Problem Report

Report Number: 3

Project Name: TeraPixel APS for CALICE **v1.1**

Item: Comparator/Pixel oscillation at low threshold

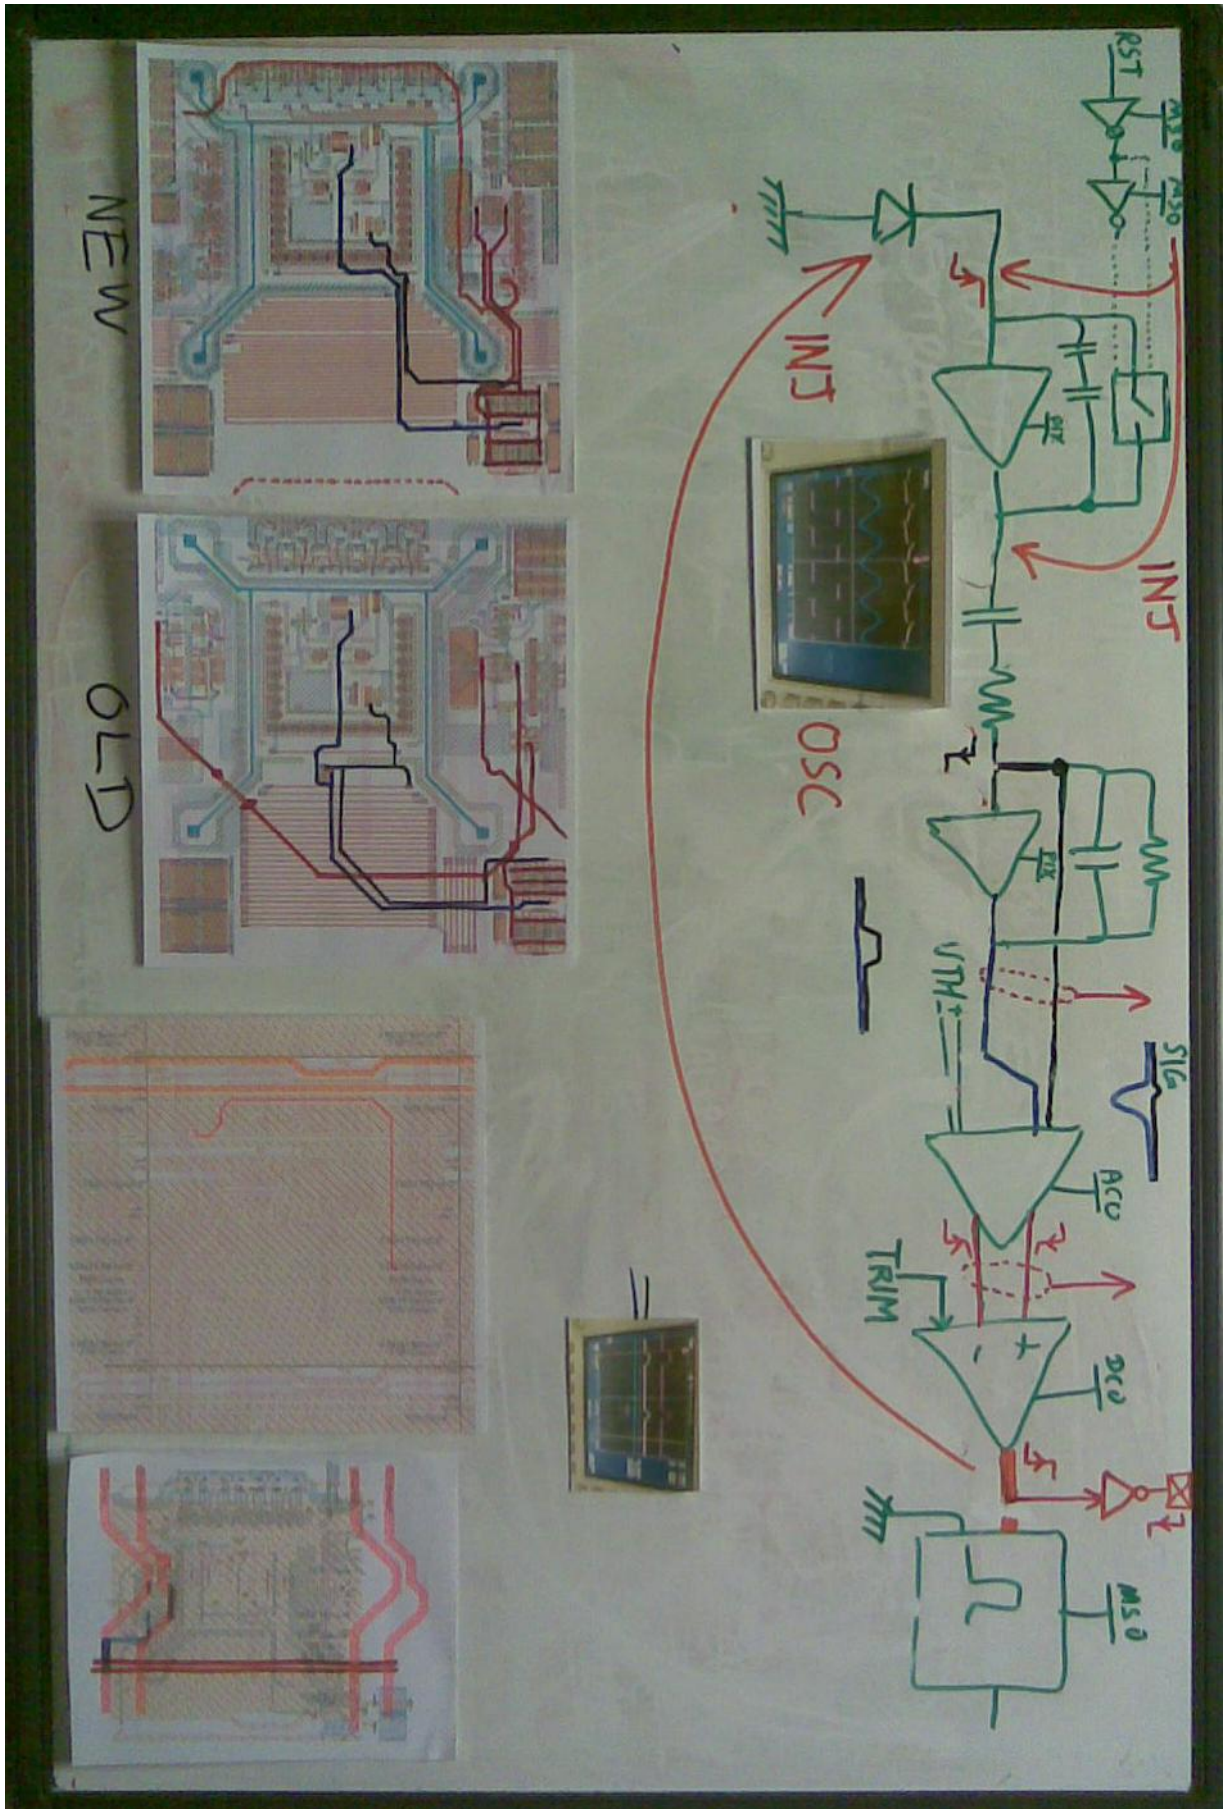
Problem
<p>Non-gaussian threshold scans were reported with very steep sides. Unusual comparator operation was also observed in the test pixels when very low thresholds were applied, resulting in oscillations: These are believed to explain the steep sides to the threshold scan.</p> <p>Further investigation shows that positive feedback occurs for extremely small parasitic coupling between the comparator output and the diode node. When the threshold is sufficiently low this coupling results in natural oscillation.</p> <p>Full RCX extraction and simulation confirms that the new pixel layout contains sufficient parasitic capacitance between the critical nodes to oscillate at low thresholds. Evaluating the important nets reports:</p> <p><u>Original design</u>: no parasitics reported between HIT (orange on layout) and DIODE (pale blue on layout) <u>New design</u>: 30aF parasitic capacitance between HIT and DIODE</p> <p>Sanity check: Can a 1.8v digital signal switching through 30aF cause problems?</p> <p style="padding-left: 40px;">$Q=CV$ so $Q = 1.8 * 30E-18 = 5.4E-17 = 337e- \sim 47mV$ signal ...yes it can!</p> <p>Note that any RCX simulation undertaken prior to submission was unlikely to find this problem due to the low threshold that must also be set to trigger an oscillation.</p> <p style="text-align: right;">{see also: attached diagrams }</p> <p>Originator (Sign/Date)</p> <p>Non-gaussian threshold scan reported by PD at IC Full analysis & interpretation of analogue testing: JC Simulation & modelling: JC</p> <p>Project Manager (Sign/Date)</p>

Remedial Action
<p>A modified pixel layout has been trialled that increases the shielding scope of M2 to better protect DIODE from HIT signal.</p> <p><u>Revised design</u>: no parasitic capacitance reported between HIT and DIODE.</p> <p>This revision makes changes to M2 only so a possible single-mask change re-manufacture would be possible (foundry permitting).</p> <p>Clearly any new design must treat the DIODE node with ultimate caution, particularly with regards any digital switching signal, but specifically the HIT node as it closes a positive feedback loop.</p> <p>RCX simulation at low threshold is essential for any future design to pre-empt any similar effects.</p> <p>Project Manager (Sign/Date)</p>
